Standards Committee

Meeting Agenda

TITLE	Champion
1st time to Committee. Twenty (20) proposed drawings and revisions to WVDOH Standard details Book – Volume 2. The sheets are listed below. A summary of each sheets revisions are included in the meeting packet; and proposed sheets have revised areas highlighted yellow. a) <i>TE1-3A Roadside Sign Supports Steel Beam Type</i> b) <i>TE1-3B Roadside Sign Supports Steel Beam Type</i> c) <i>TE1-3C Roadside Sign Supports Steel Beam Type</i> d) <i>TE2-1A Bridge or Retaining Wall Sign Mounting, Type K 1 & 2 Supports</i> e) <i>TE2-1B Bridge or Retaining Wall Sign Mounting, Type K 1 & 2 Supports</i> f) <i>TE2-2 Bridge or Retaining Wall Sign Mounting, Type L Pipe Post Mount</i> g) <i>TE2-3 Barrier Wall Sign Support Bracket Type D</i> h) <i>TE3-1 Overhead Sign Support – Steel Two Tube Span (TTS)</i> i) <i>TE3-2 Overhead Sign Support – Steel One Tube Span (OTS)</i> j) <i>TE4-3A Overhead Sign Support – Steel Double Arm Cantilever</i> k) <i>TE4-3B Overhead Sign Support – Butterfly Cantilever</i> l) <i>TE4-4A Overhead Sign Support – Single Arm Cantilever (Heavy)</i> m) <i>TE4-4B Overhead Sign Support – Single Arm Cantilever (Light)</i> n) <i>TE4-5

Figure 1042.B

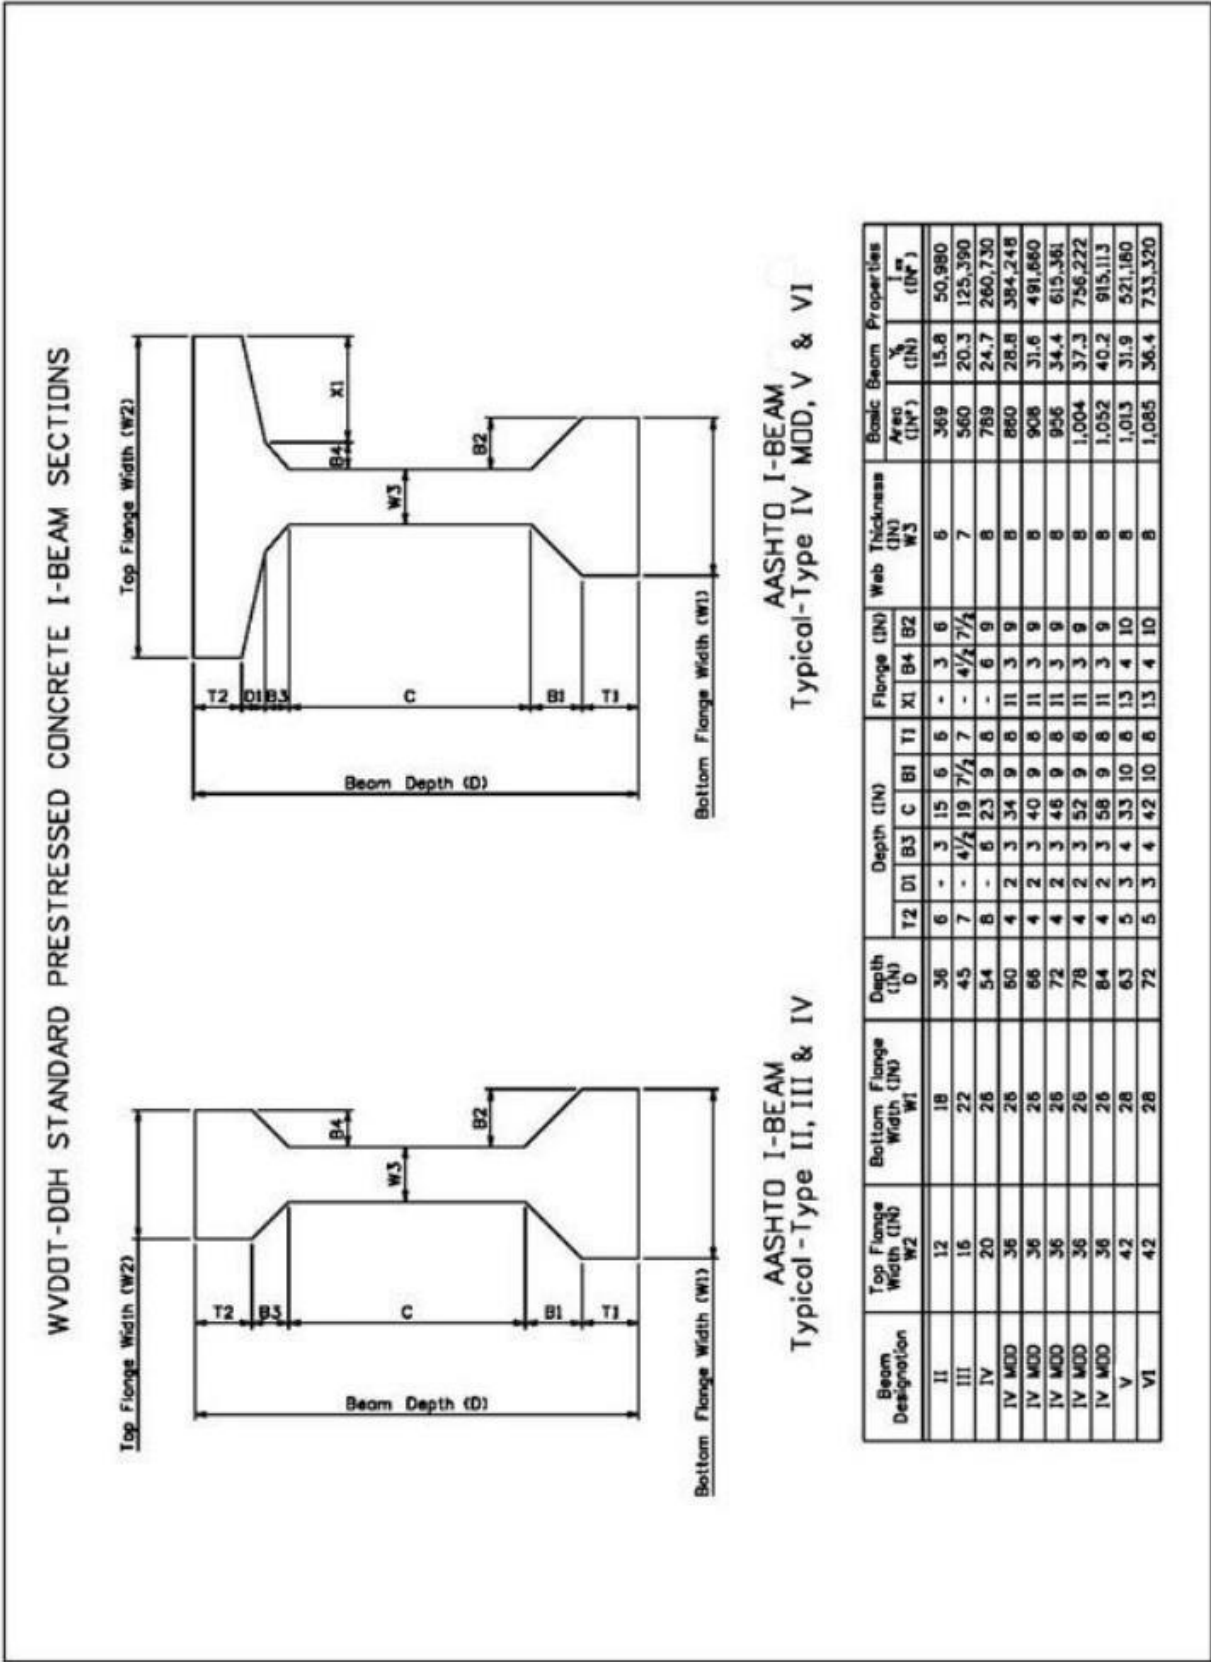
Prestressed concrete beams should be considered for bridges with spans from twenty-five (25) feet to ~~145~~ 160 feet. The maximum span length is based on the haul capacity and availability for a particular project site and shall be verified with a prestressed concrete beam supplier familiar with the project location. For continuous spans, the bridge system shall be designed simply supported for dead load and continuous for live load and superimposed dead load only. The same prestressed concrete beam type is desired for all spans. The Designer should minimize the number of beam lines. Prestressed concrete beam bridges should have a minimum of three stringer lines.

STANDARD SHEET TE1-3A

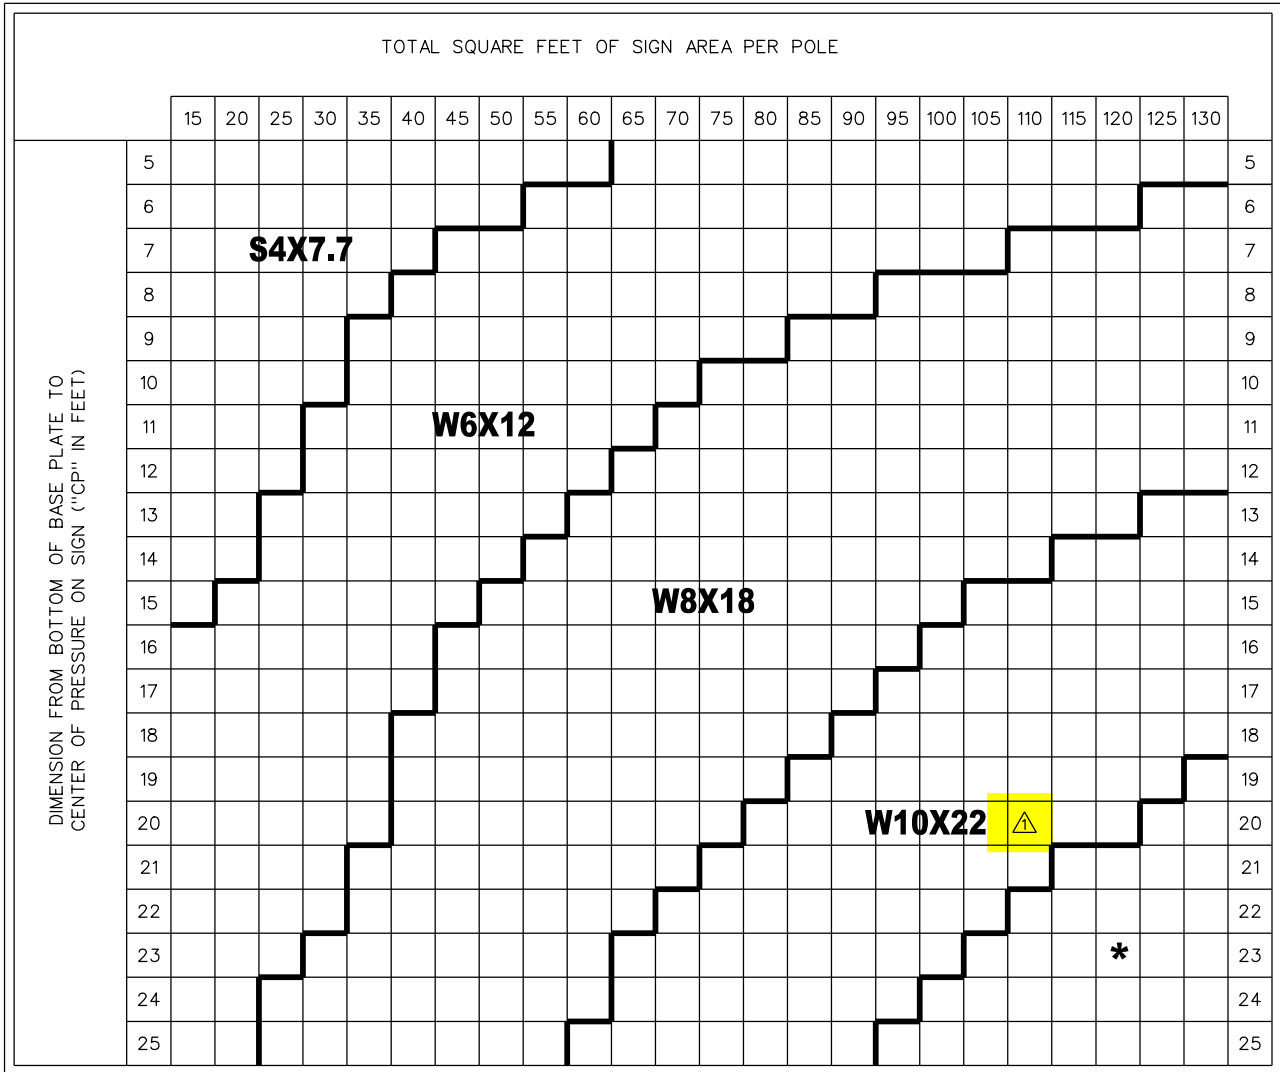
Sheet	Revision #	Date	Summary
TE1-3A	1	4/2022	Returned hinge plate dimensions to the previous standard. Revised T3 & D3 for S4 and W6 supports
TE1-3B	1	4/2022	Removed note allowing use of W10X22 behind guardrail or on a bench.
TE1-3C	1	4/2022	Returned to previous foundation sizes.
TE2-1A	1	11/11/2022	Increased the base plate to allow for more fasteners due to structural loads. Revised Note 1 to remove reference to three post option and to limit sign width to 6'. Revised Note 3 to clarify loads for fabricator to specify anchors. Added note to verify that the concrete structure mounting to will support these loads.
TE2-1B	1	11/11/2022	This option for three posts is not to be used. Loads are too great for typical bridge parapet.
TE2-2	1	11/11/2022	Increased the base plate to allow for more fasteners due to structural loads. Increased the number of required anchor bolts. This bracket is only allowed for Pipe Post Types 6 & 9. Note 4 was added to clarify loads for fabricator to specify anchors for retrofit option.

**BRIDGE OR
RETAINING WALL
SIGN MOUNTING
TYPE L
PIPE POST MOUNT
STANDARD SHEET TE2-2**

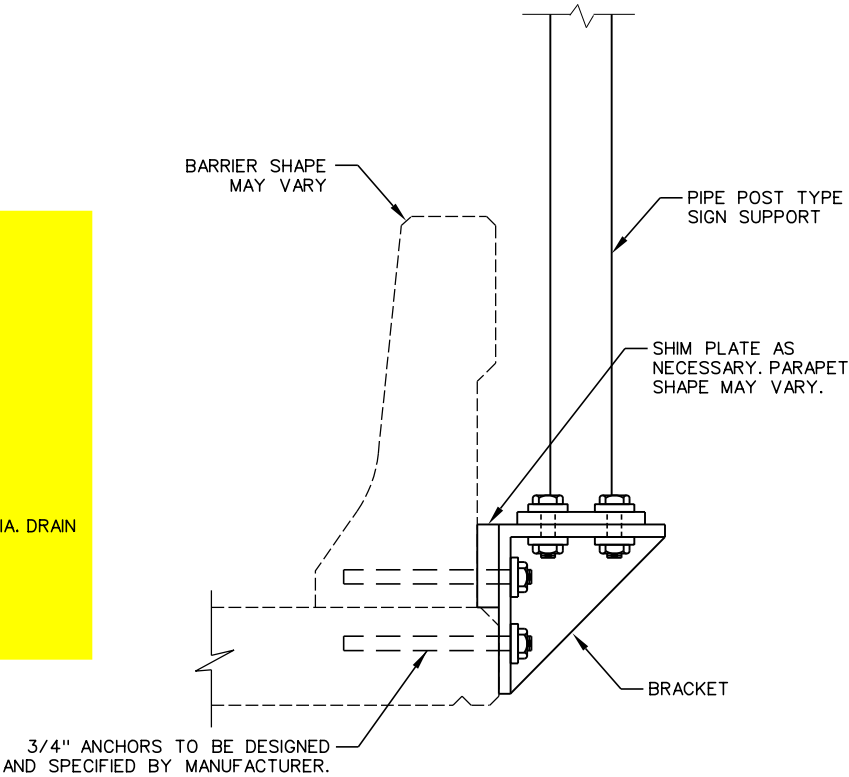
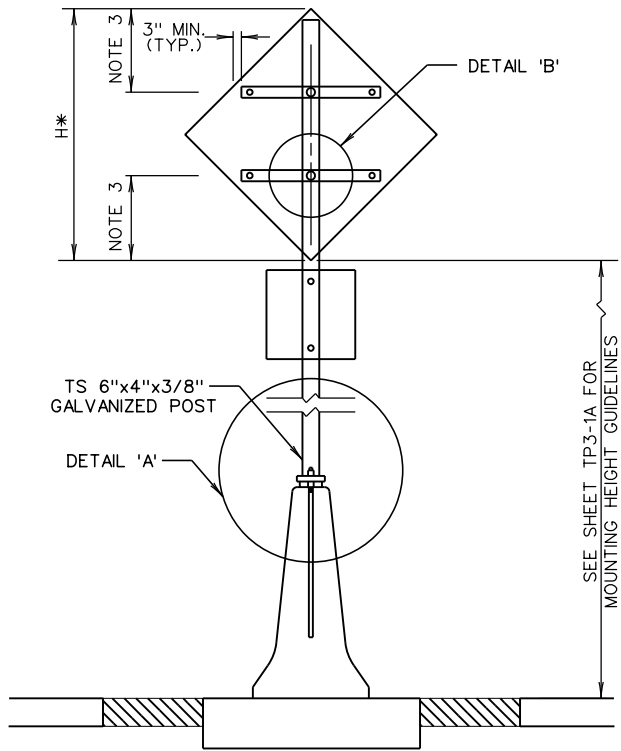
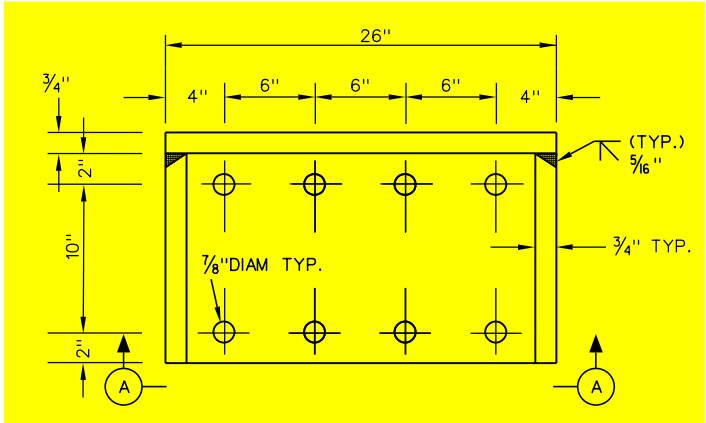
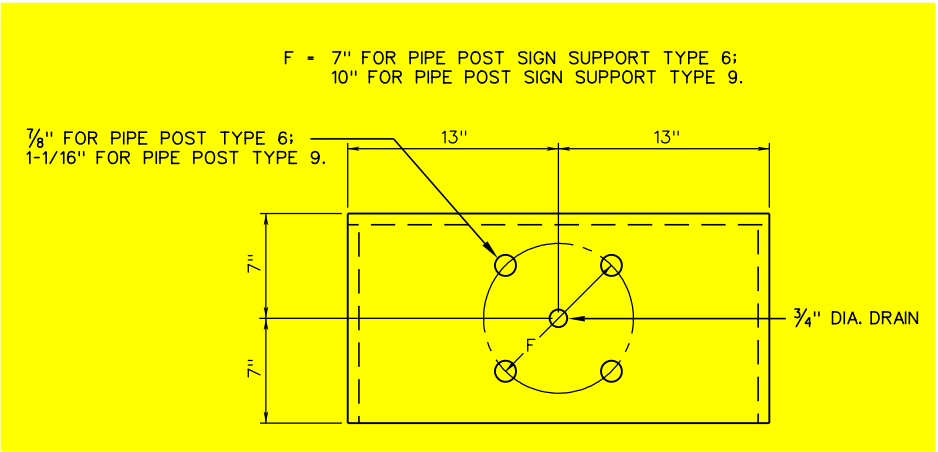
ADDED NOTE 4.
REMOVED REFERENCE TO TYPES 7 & 8.
INCREASED WIDTH OF BRACKET AND
INCREASED NO. OF ANCHORS TO 8.
